RESPONSE TO SUBMISSIONS DESIGN REPORT

1 BARRACK LANE, 81-83 GEORGE ST, PARRAMATTA

APRIL 2026

DESIGN RESPONSE
2.9 TRAFFIC

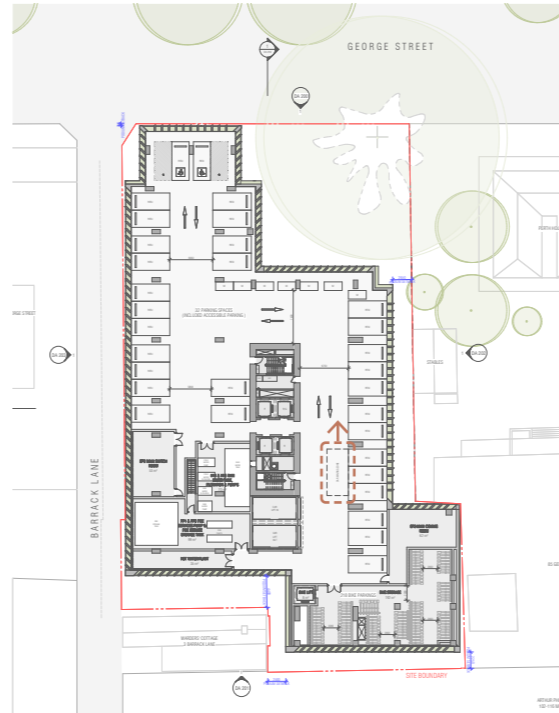
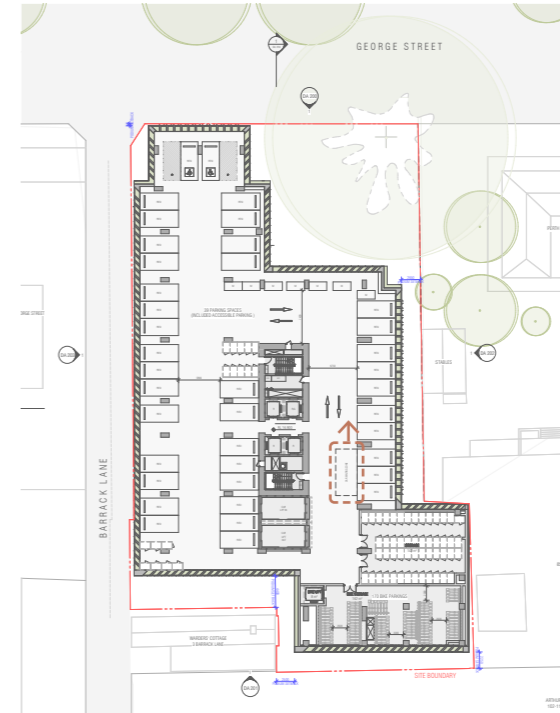
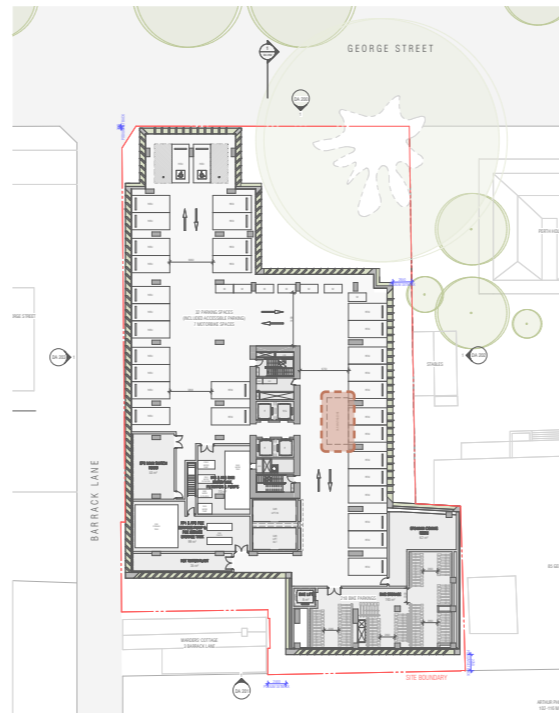
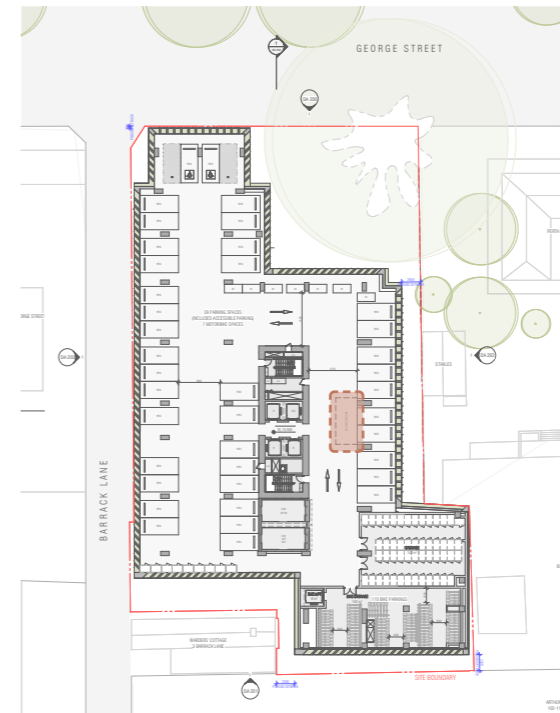
COP - 35

The parking levels have been revised to incorporate updated waiting areas to improve vehicle circulation and operational efficiency. These adjustments have been coordinated with and verified by the project traffic engineers.

RTS LEVEL 1 PARKING
 CAR WAITING ZONE MOVES UP

RTS LEVEL 2 PARKING
 CAR WAITING ZONE MOVES UP
